Economic Commission for Europe**Inland Transport Committee****Working Party on Customs Questions affecting
Transport****Group of Experts on Conceptual and
Technical Aspects of Computerization of the TIR Procedure****Third session**

Geneva, 13–15 September 2021

**eTIR conceptual, functional and technical documentation version 4.3:
Amendments****Amendments to the eTIR conceptual, functional and
technical documentation****Note by the secretariat****I. Introduction**

6. Furthermore, in the same document, figure 20 (General eTIR class diagram) should be amended as follows:

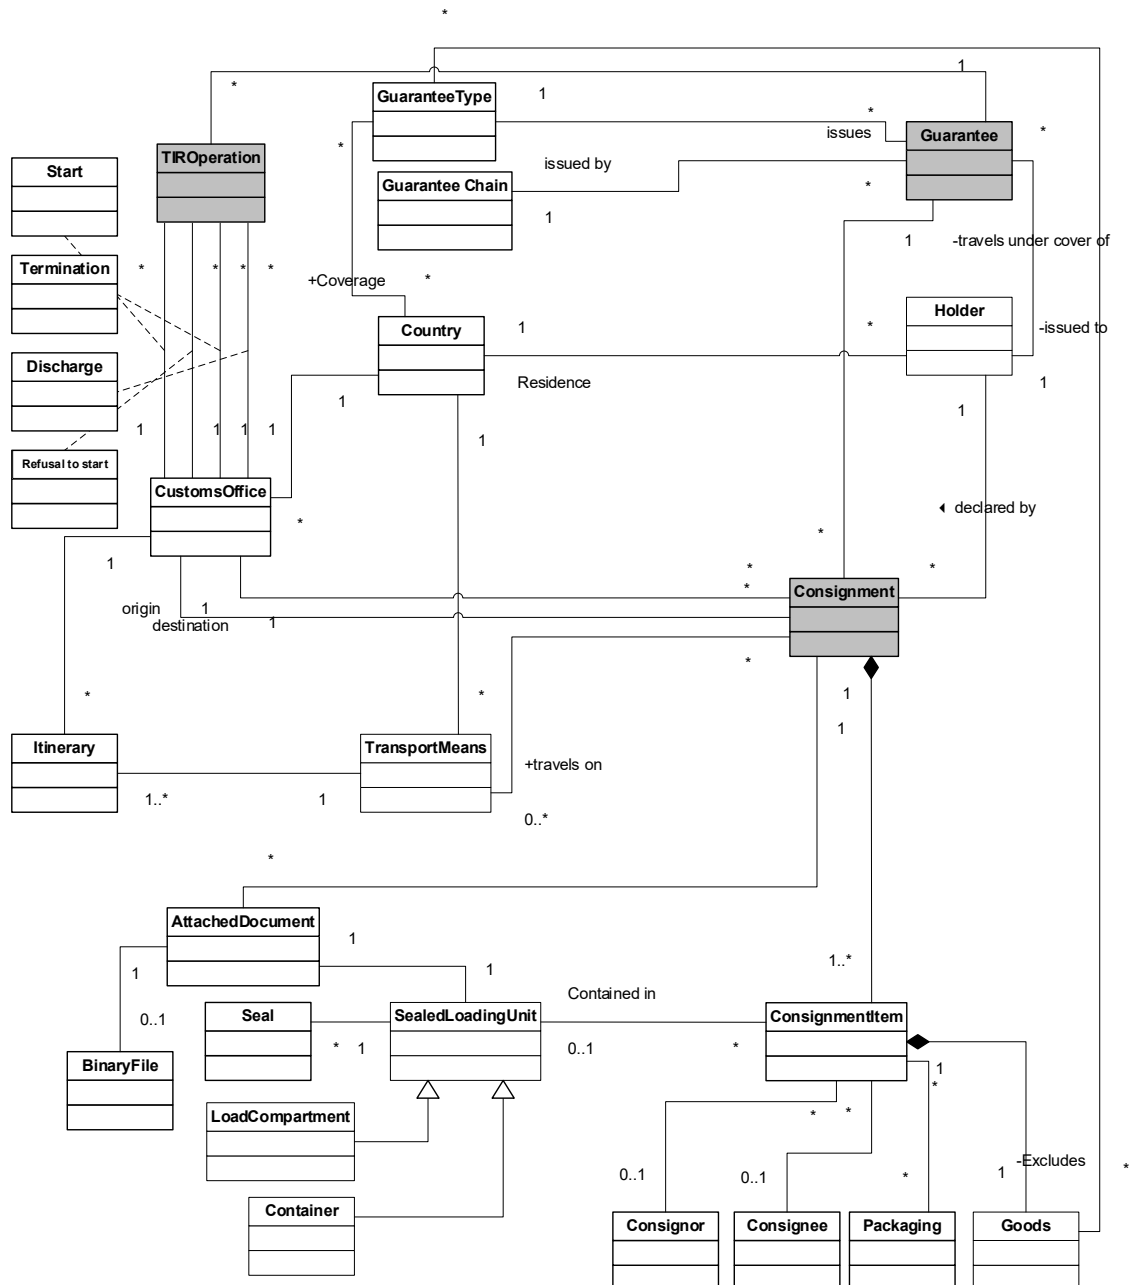
7. Then, in the eTIR Functional specifications, in order to better reflect the role of the former “CountryOfRouting” class (WCO ID:81A), its eTIR name should be aligned with the WCO name, i.e. “Itinerary”.

8. In that class, the WCO Class “ItineraryGovernmentOffice” will be made available and have “Customs office” as eTIR name. Two attributes will be added to that class: “Identifier” and “Role, coded”, the latter having to be added to the WCO data model.
